Re: *WMG Acquisitions LLC*
Amended Site Plan Application – BaySpace Armonk
100 Business Park Drive (108.03-1-51)

RE: JMC Project 22090
BaySpace Armonk
100 Business Park Drive
Town of North Castle, NY

Response to Town Comments Resubmission

BUILDING ELEVATIONS

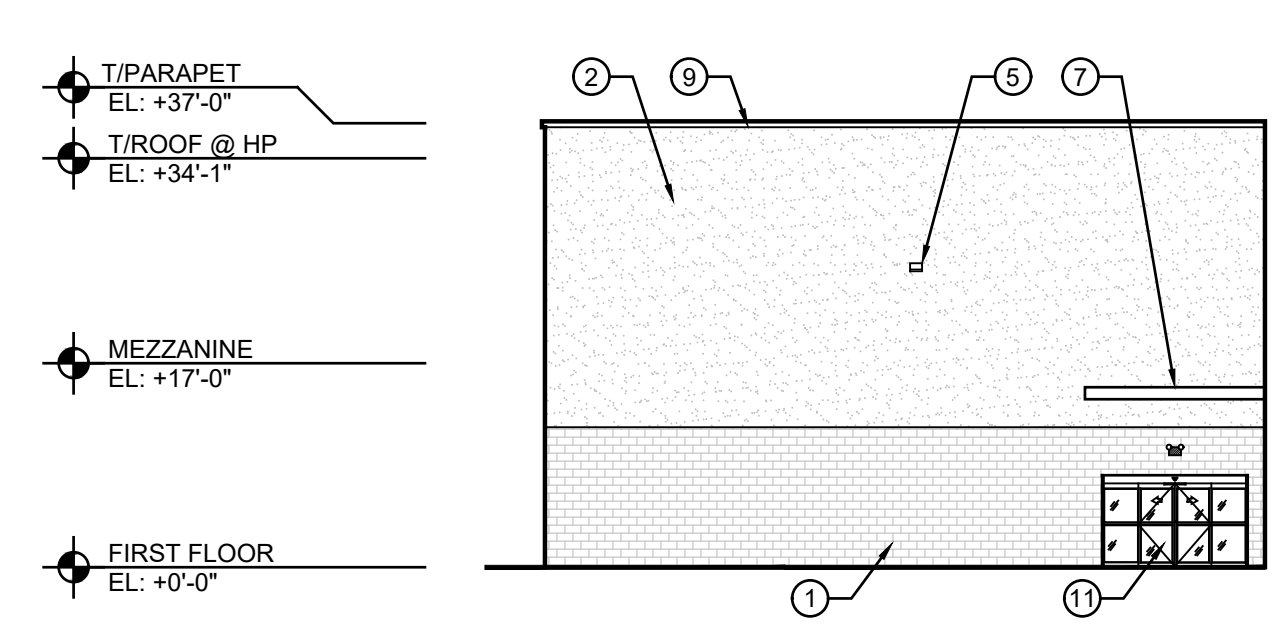
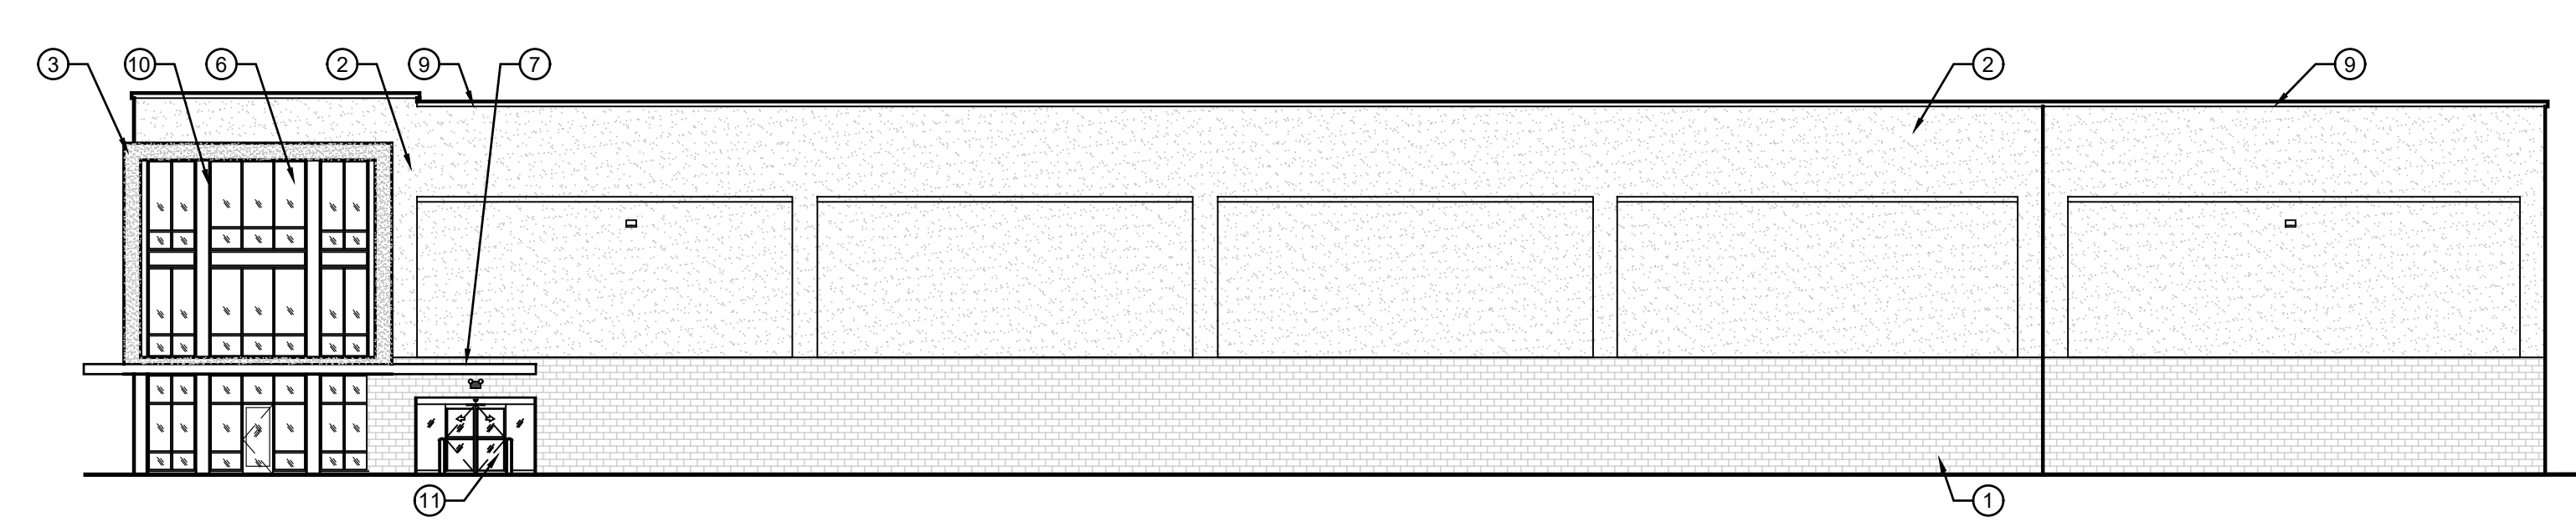
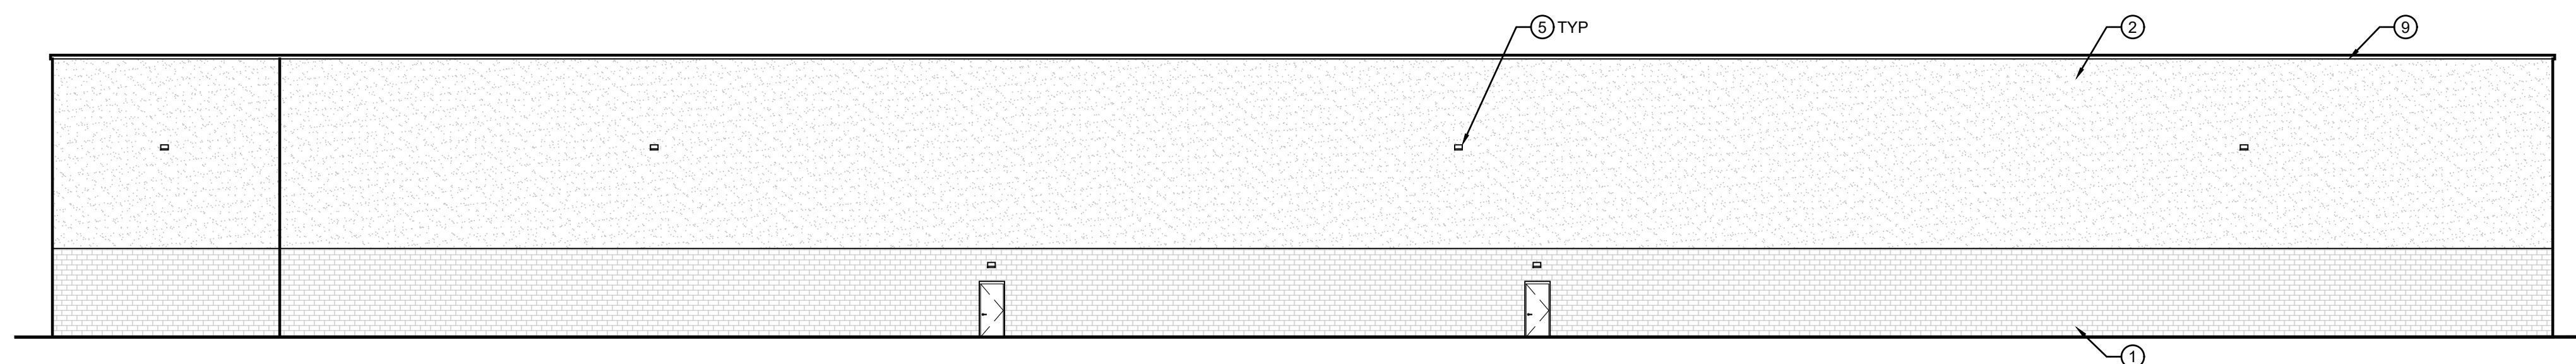
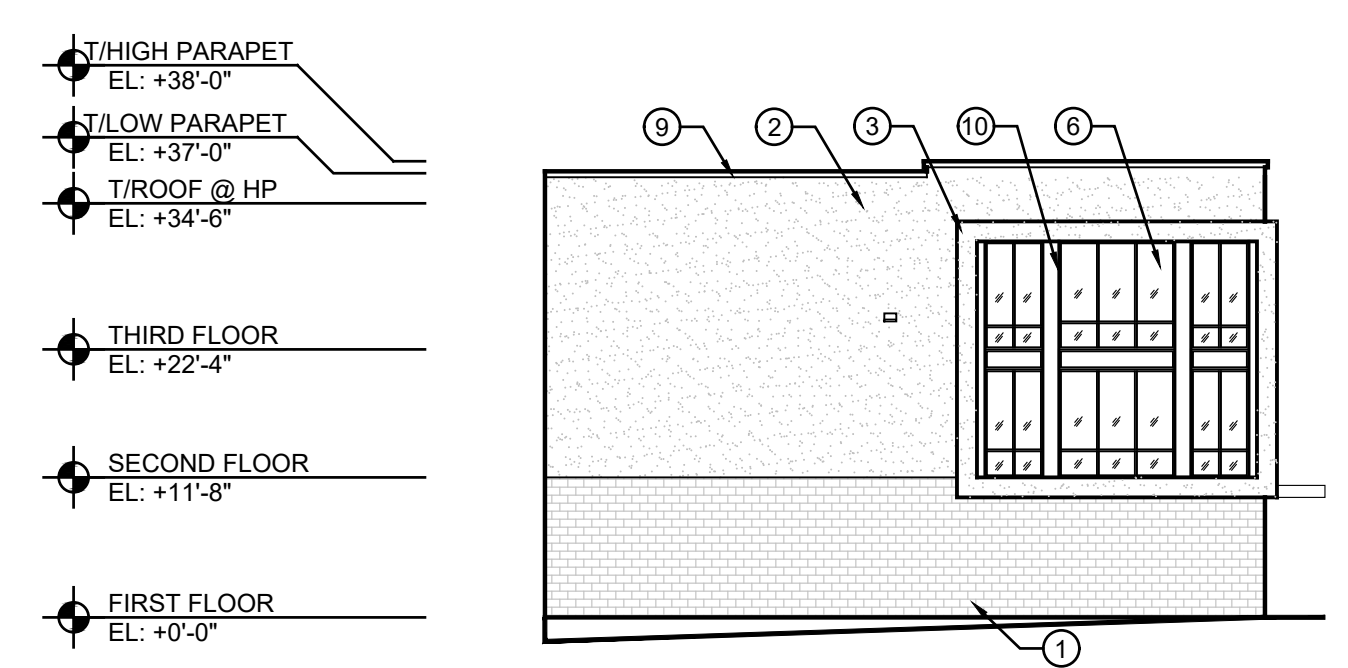
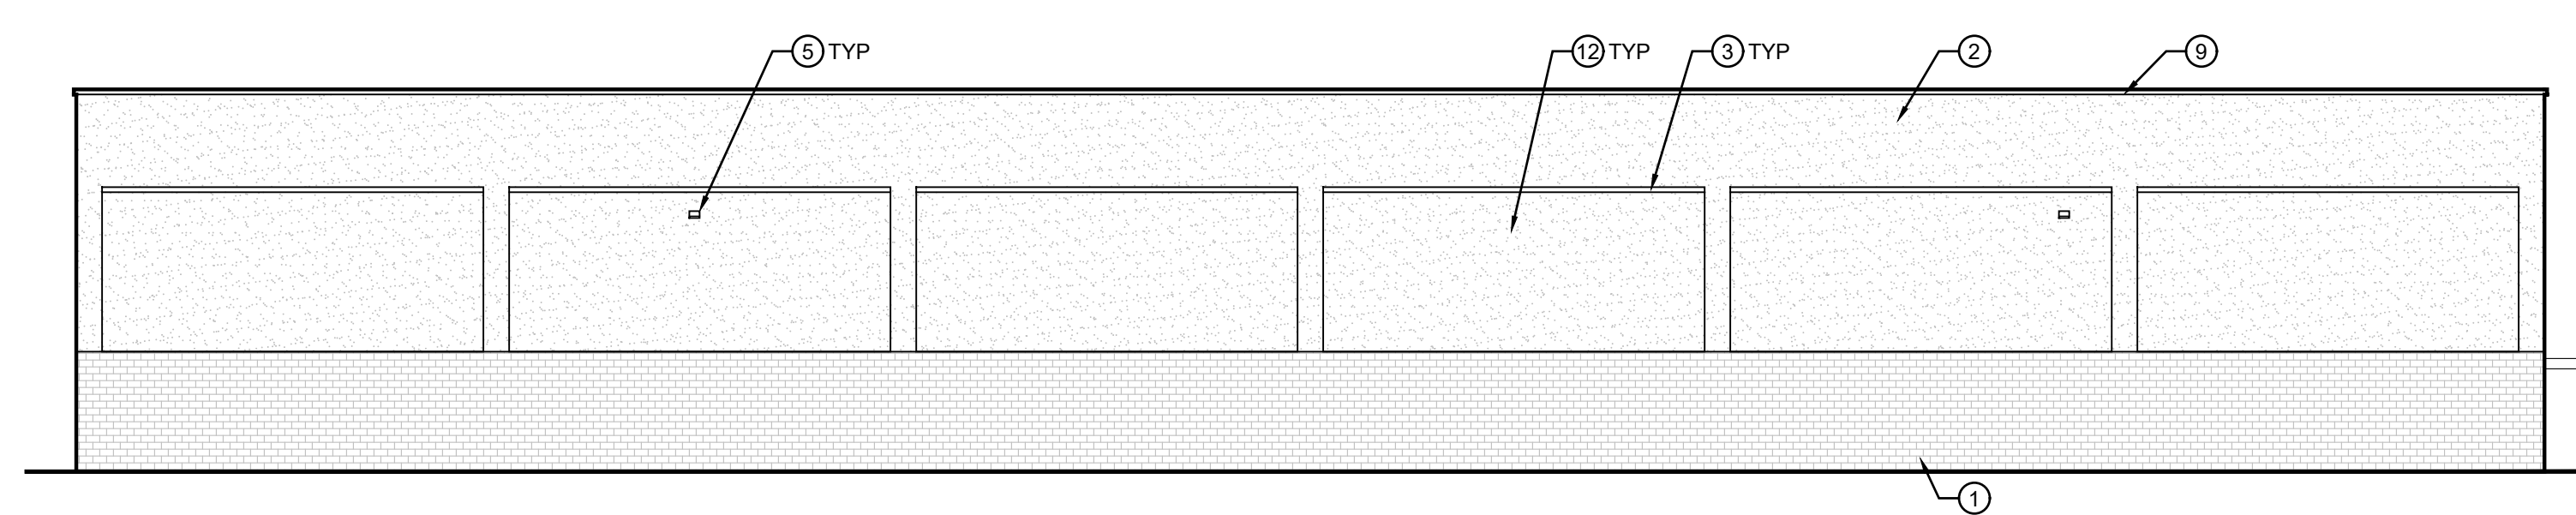
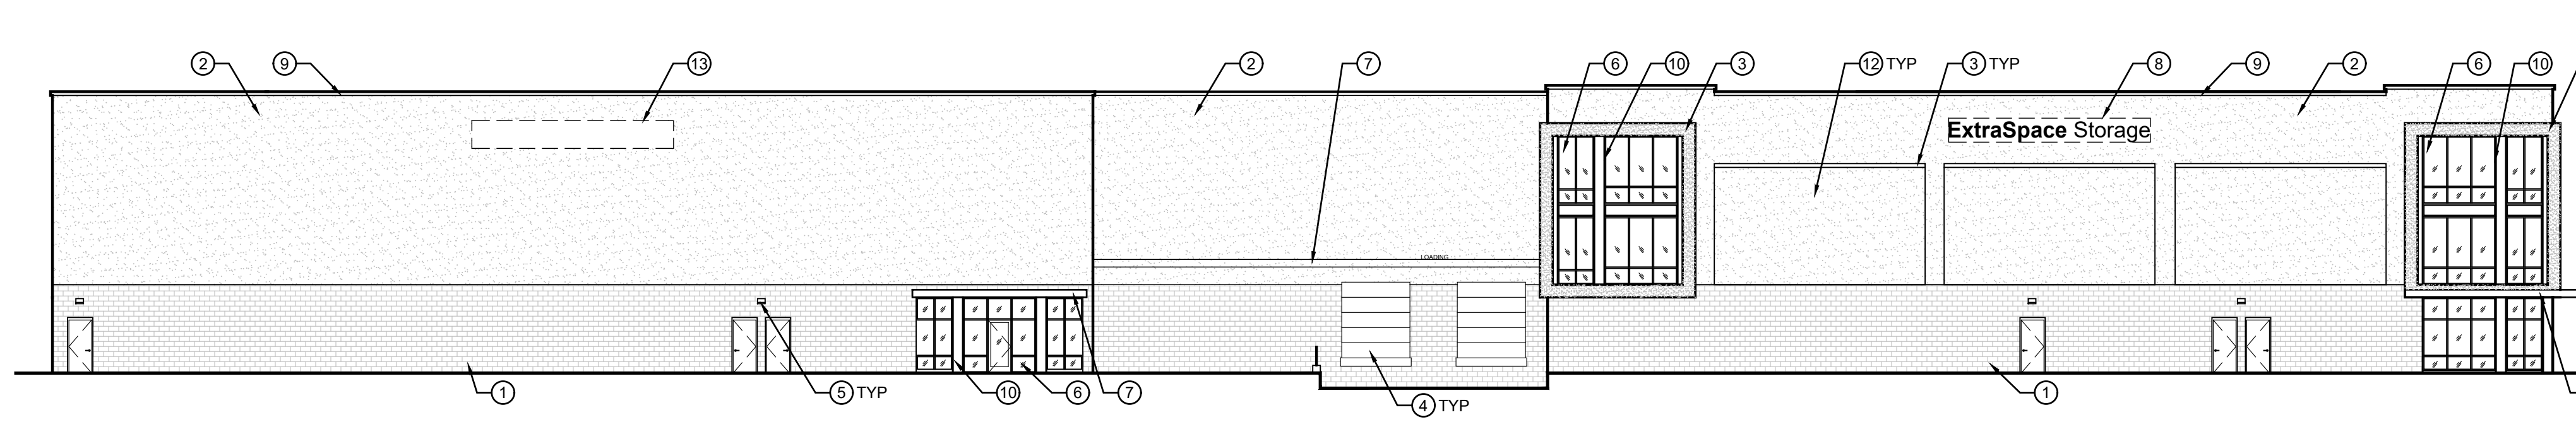
The submitted elevations shall be revised to depict proposed Building Height (average grade to top of roof). Building Height can't exceed 35 feet in the PLI Zoning District.

The building elevations have been revised to depict the proposed Building Height. Refer to SGW Architecture & Design drawing A-201 "Building Elevations", last revised 10/24/2022. An average grade calculation will be prepared and provided under separate cover.
